City Commission
June 3, 2008

Gables Waterway

Overview of presentation

## 2. Incompatible transition of massing (pgs 15-18)

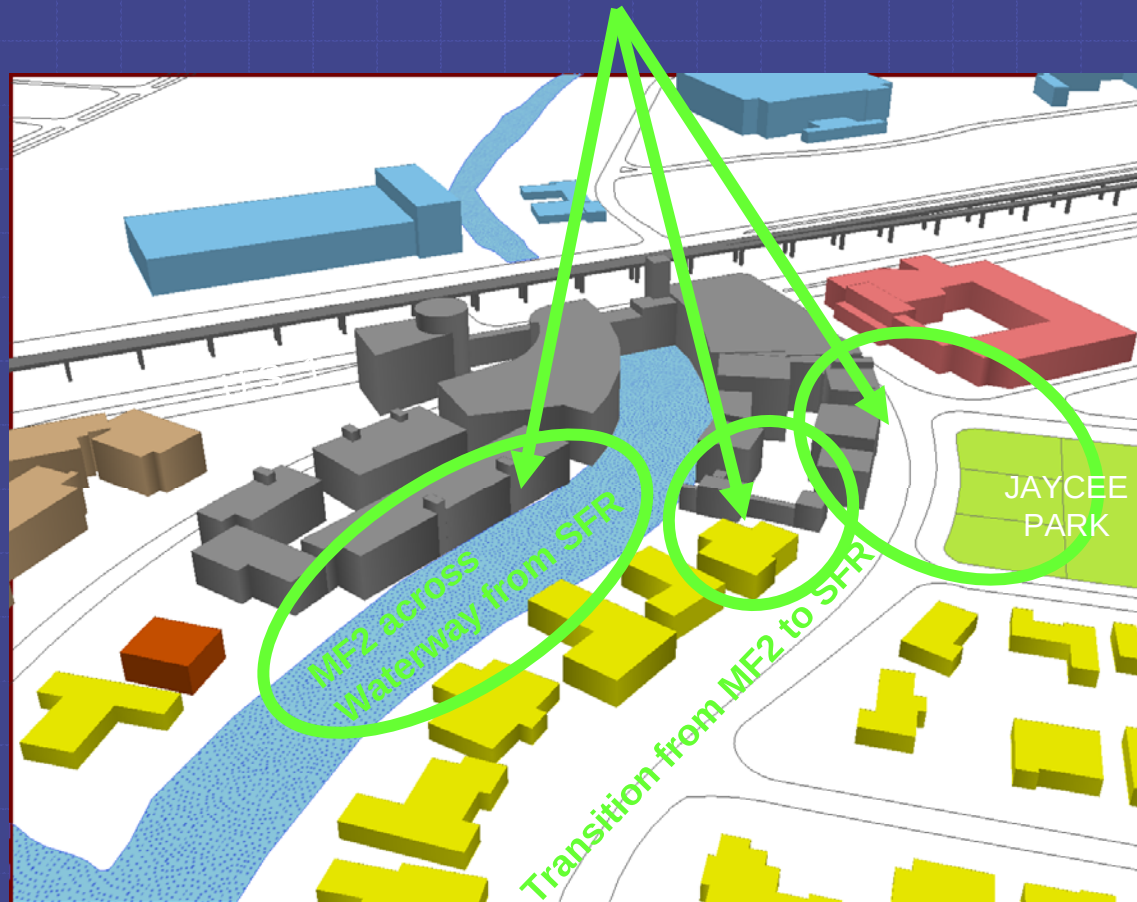
- Project does not provide adequate **transition of massing**
- Project does not provide adequate transition in **height and scale** from U.S.1 back to the existing single-family and duplex uses
- 5 story height of residential building across from **Jaycee Park**, and proposed reduction of both the required **front and rear setback** of the project's multi-family residential structures would impact adjoining properties and single-family residences located across the canal

## Comparison of Allowed/Existing and Proposed Development

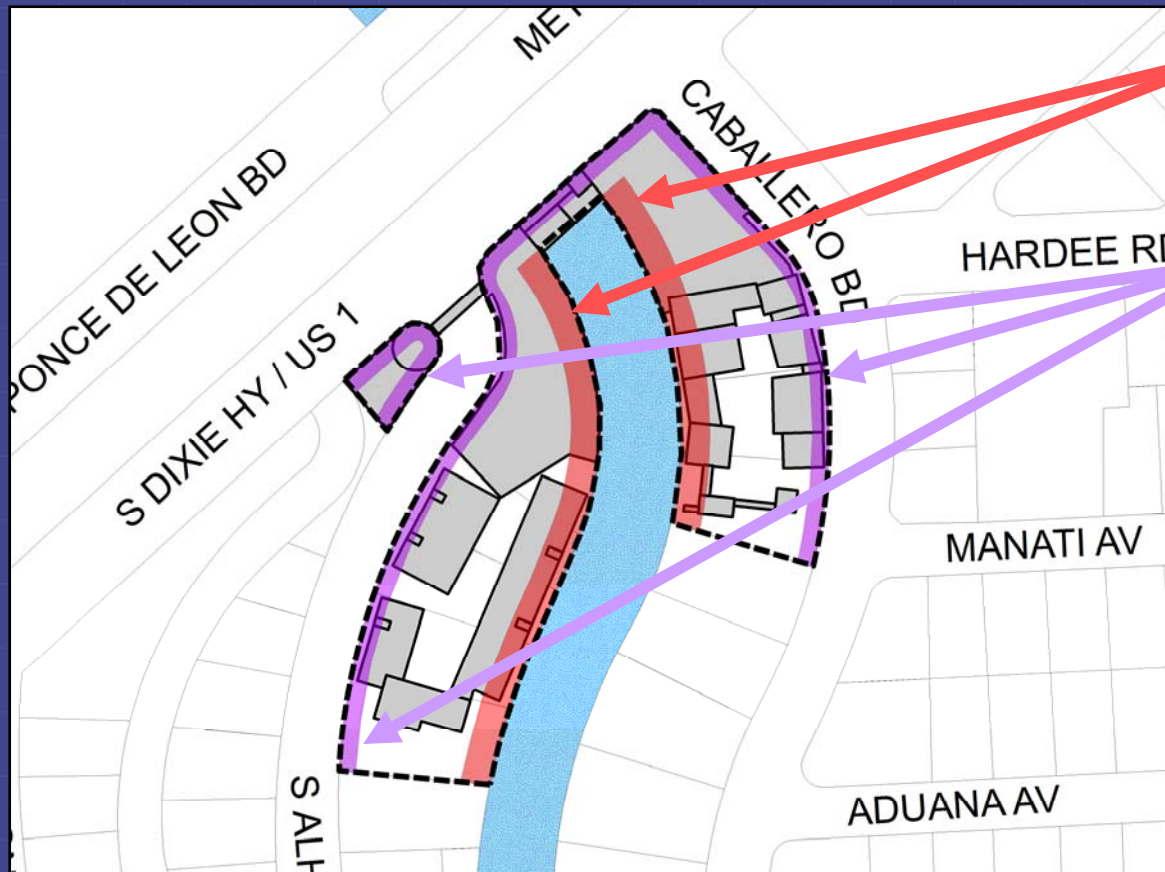
- Project's size and density are **inconsistent with scale and character** of the surrounding neighborhood
- Applicant's proposed mitigation **does not support the award of requested site development bonuses**
- Proposed project with bonuses (setback relief, building height and additional residential units) results in increased project size, loss of open space and existing tree canopy, and insufficient transition and buffering between uses which are **inconsistent with the scale and character of the surrounding neighborhood**
- Would **encourage further incompatible redevelopment**
- Preliminary Zoning Analysis indicates the 20% on-site landscape open space required for a PAD has not been met and the **applicant requires credit for off-site landscaping**

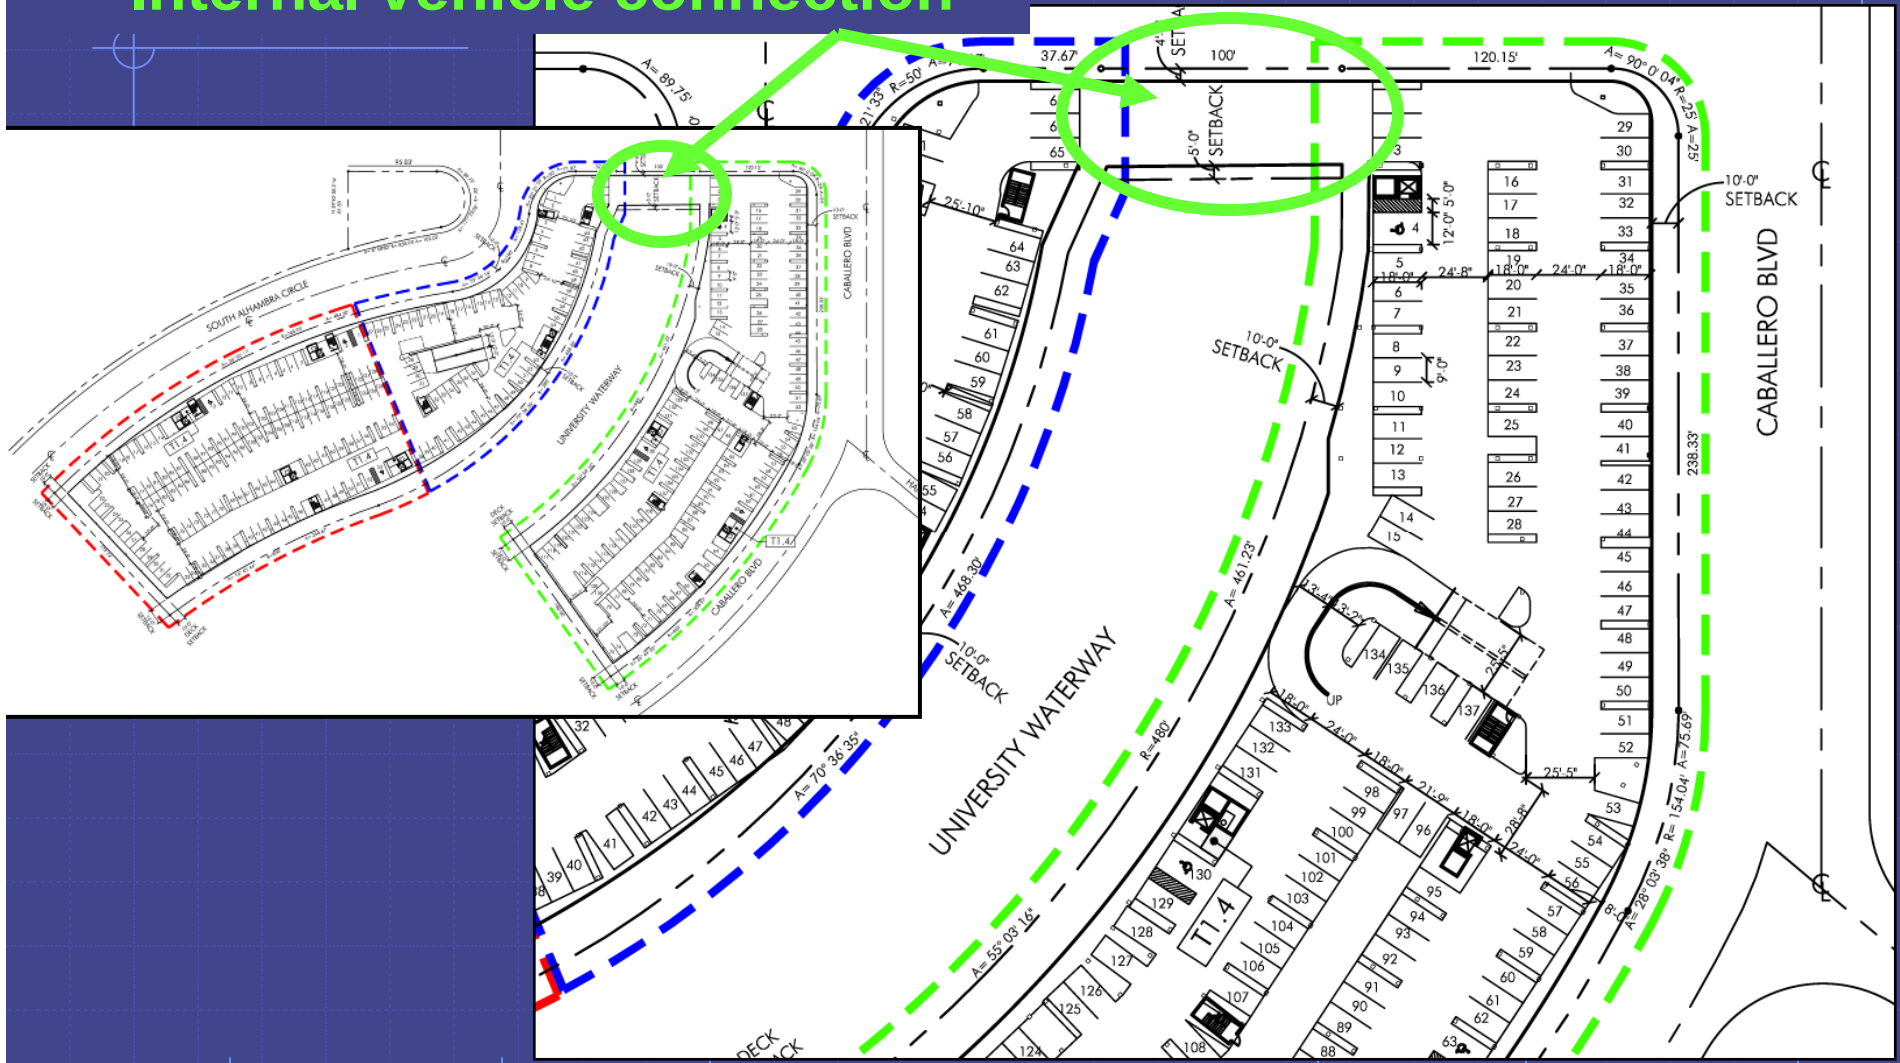
4. **Potential off-site parking encroachment (pgs 21-23)**
- Parking generated by the project could **encroach into the surrounding neighborhood** if left unmanaged
  - **No overflow parking management plan**, including short term meters, residential parking permits, directional signage and enforcement measures is provided to ensure that parking does not spill over into the surrounding residential neighborhood.
  - No plans provided for the proposed **vehicle connection** between the underground parking areas that would allow and encourage on-site vehicular circulation

## 6. Project phasing (pgs 26-32)

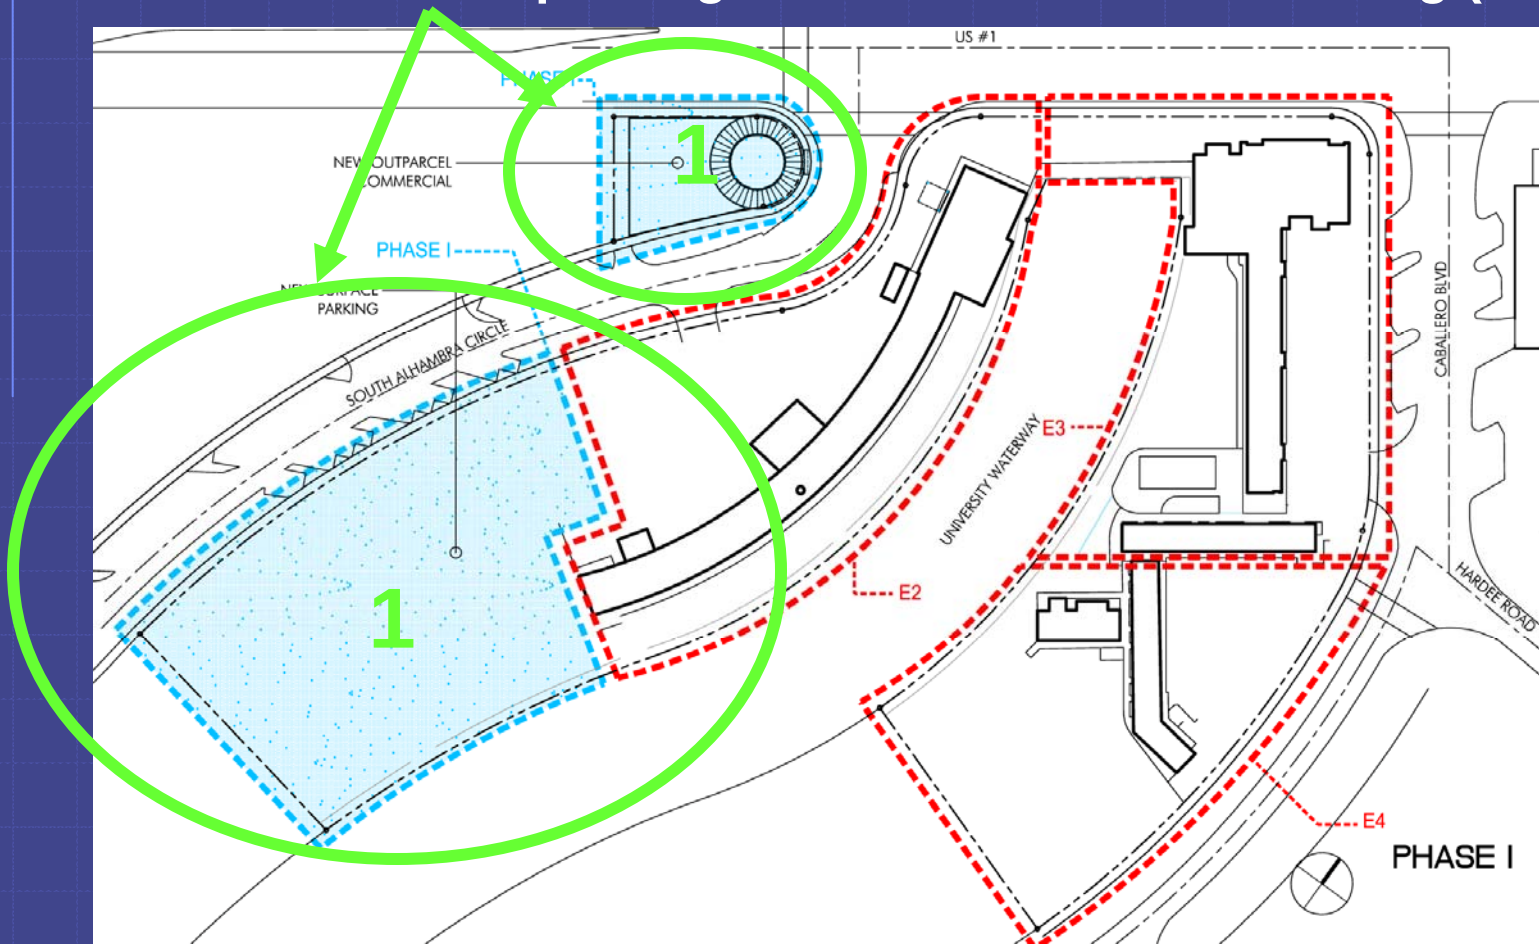
- Project is proposed to be developed in various phases, which if left unplanned and/or unchecked, could result in significant **impacts to the surrounding neighborhood**
- **No assurances provided** that the project fulfills the PAD objectives and purpose if the project is not built-out and all proposed phases constructed
- A **projected timeline is necessary** for each phase of the project and for the build-out of the entire project
- No proposed use of **proposed interim surface parking lot** or plan has been submitted providing details showing vehicular entrances, paving/curbing, landscaping, lighting and pedestrian circulation

## Lack of marina facilities operation plan

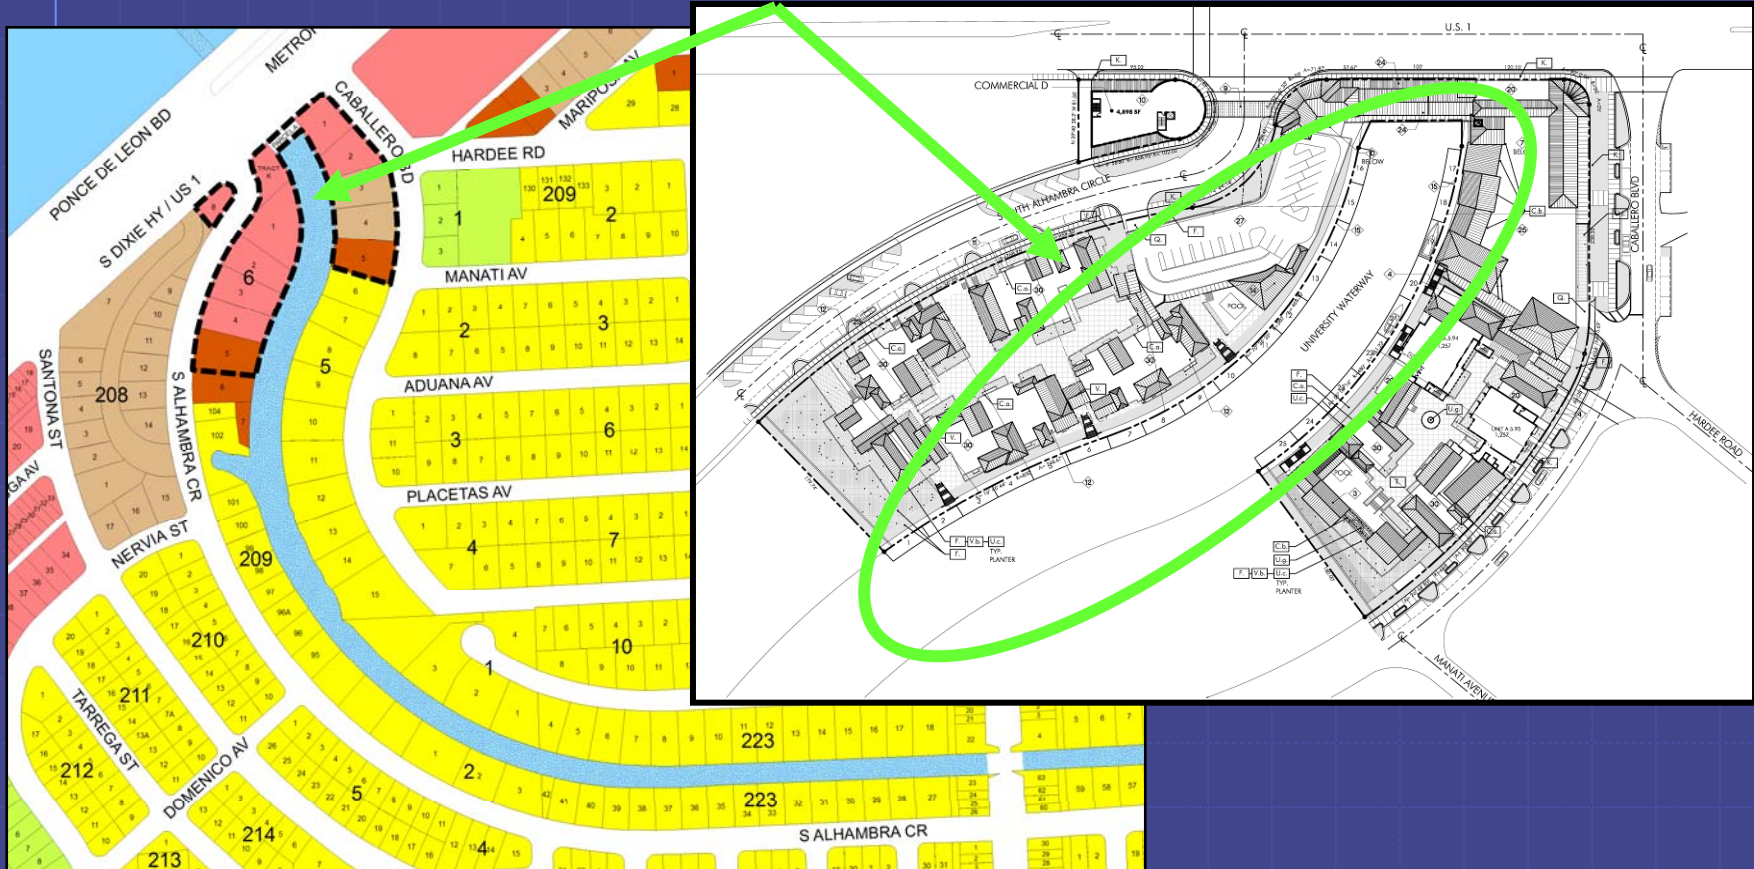
- Project will result in **increased use of existing marina** situated along **ecologically sensitive canal habitat**, which, if left unmanaged, could negatively impact the canal and surrounding single-family residential neighborhood
- **No operational plan provided** for the renovation and use of the existing 25 boat berths that are proposed to be assigned to owners of new residential units
- Marina is located at the end of a canal utilized primarily by the existing single-family residential neighborhood through which the canal courses, and serves as an environmentally sensitive manatee habitat
- Application **does not sufficiently address the servicing of vessels** at the marina to ensure there is minimal impact on the surrounding residential neighborhood and existing manatee habitat along the waterway
